OPERATIONAL TEST
AND EVALUATION

AUG 09 2016

MEMORANDUM FOR UNDER SECRETARY OF DEFENSE FOR ACQUISITION,
TECHNOLOGY AND LOGISTICS
SECRETARY OF THE AIR FORCE
CHIEF OF STAFF OF THE AIR FORCE

SUBJECT: Achieving Full Combat Capability with the Joint Strike Fighter (JSF) is at
Substantial Risk

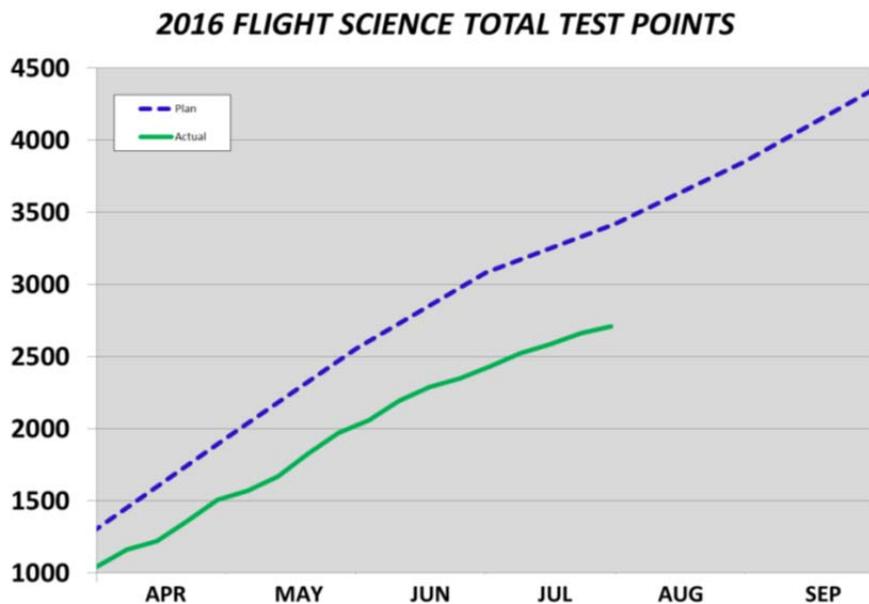
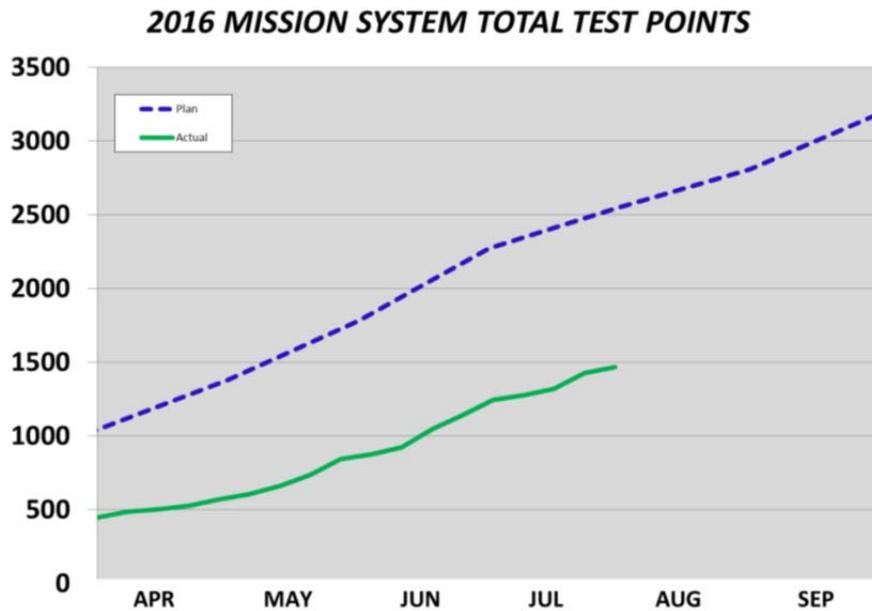
- The program is behind in flight testing of Block 3F mission systems and flight sciences testing, and is still not catching up due to a combination of factors (e.g., aggressive schedule, new discoveries, regression testing, and normal attrition for reasons like ground aborts, weather and airspace), as indicated in the program office test point completion progress charts for 2016 shown below:

How the program will be able to accomplish the balance of required test points remaining in the time and budget allotted, given historic rates and ongoing personnel reductions, is unclear.
